**PLANNING DIVISION REPORT  
DEPARTMENT OF PLANNING AND COMMUNITY  
AND ECONOMIC DEVELOPMENT  
Of September 26, 2007**

**RE: I.D. #07602, Certified Survey Map – 5306 Raymond Road**

DATE: August 31, 2007  
TO: Plan Commission  
FROM: Larry D. Nelson, P.E., City Engineer   
SUBJECT: 5306 Raymond Road Certified Survey Map

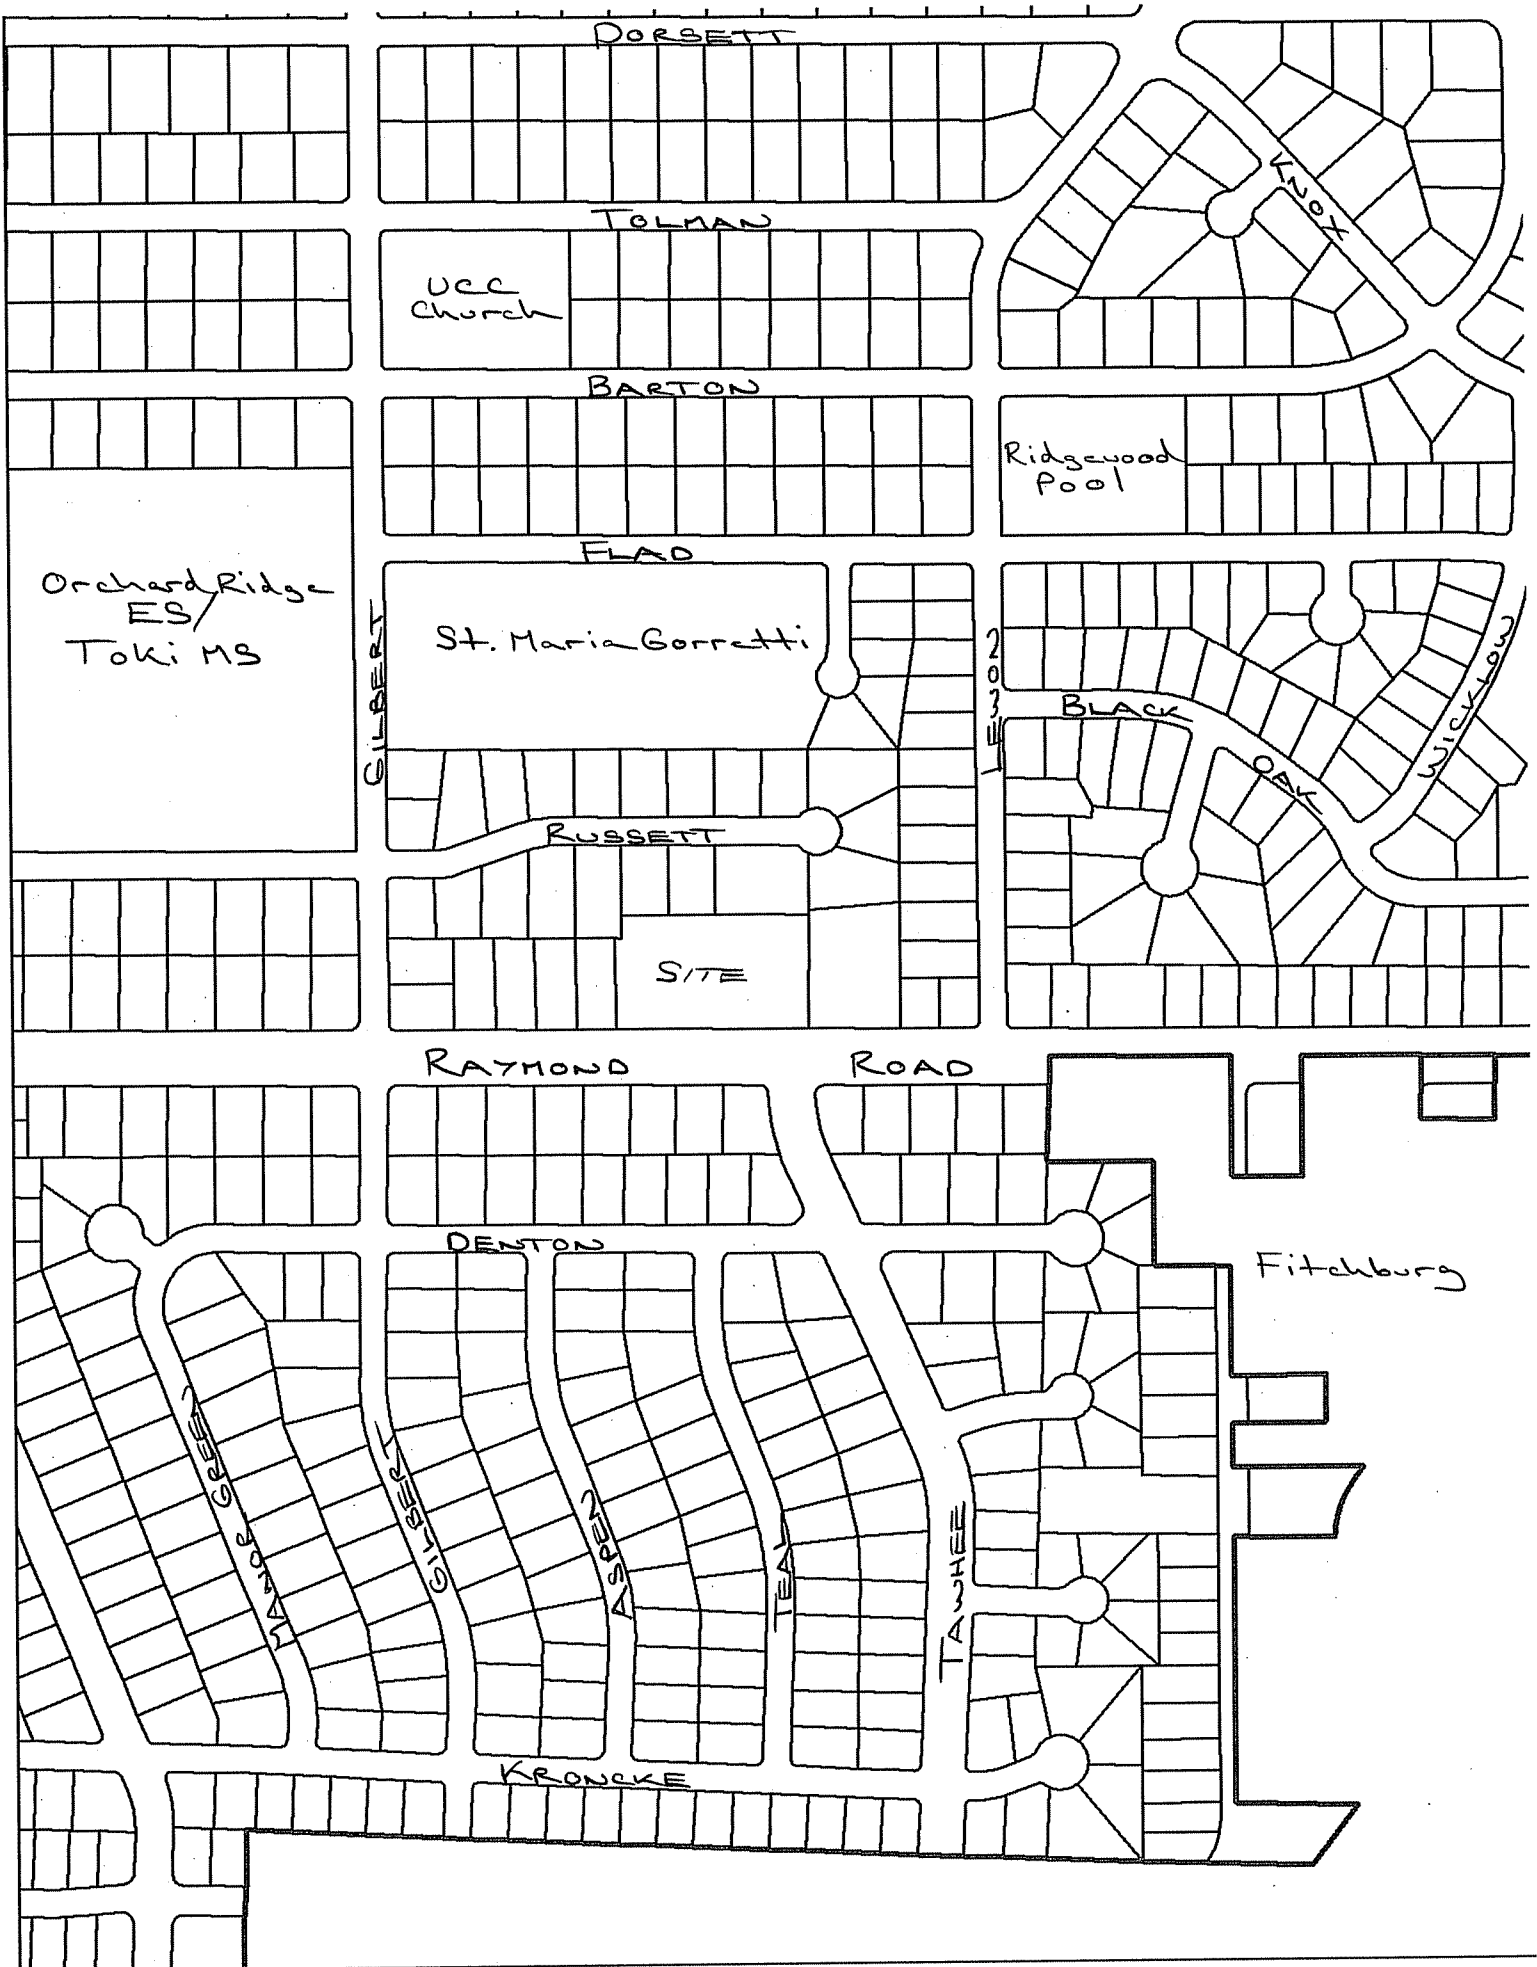
The Certified Survey Map proposes a 0.4-acre (17,499 square feet) lot, Lot 2, to surround the single-family residence in the southwest corner of the property. The five-sided lot will have 130 feet of frontage on Raymond Road and will extend 141.43 feet along the western property line. The lot will extend 112 feet along its eastern edge before turning northwesterly 67.46 feet and then due west the final 70 feet to the western property line. The rear lot lines of Lot 2 generally follow the 40-foot rear yard required in R1 zoning. The remaining 1.87 acres of the site will comprise Lot 1 of the CSM, on which the applicant indicates he will construct a single-family residence. Lot 1 will include the roughly 100 feet of the site located due north of proposed Lot 2, including a small, pre-existing 16-foot notch out of the northwestern corner of the property. In general, both lots proposed meet the minimum R1 zoning requirements, which call for lots to be at least 65 feet in width and 8,000 square feet in area. A new driveway will be constructed on Lot 2 to serve the existing residence's garage.

1. Comments from reviewing agencies.
2. That the common lot line between proposed Lots 1 and 2 extend parallel to the western property line continuously from Raymond Road to the northern property line as approved by the Planning Division.

| <ol style="list-style-type: none"> <li>1. Each lot shall have a separate sanitary sewer lateral.</li> <li>2. This CSM indicates the existing driveway is to be removed. Note that a driveway permit is needed for the new driveway. Contact City Engineering at 266-4751 for necessary permit.</li> <li>2. The Applicant shall close all abandoned driveways by replacing the curb in front of the driveways and restoring the terrace with grass.</li> </ol> |
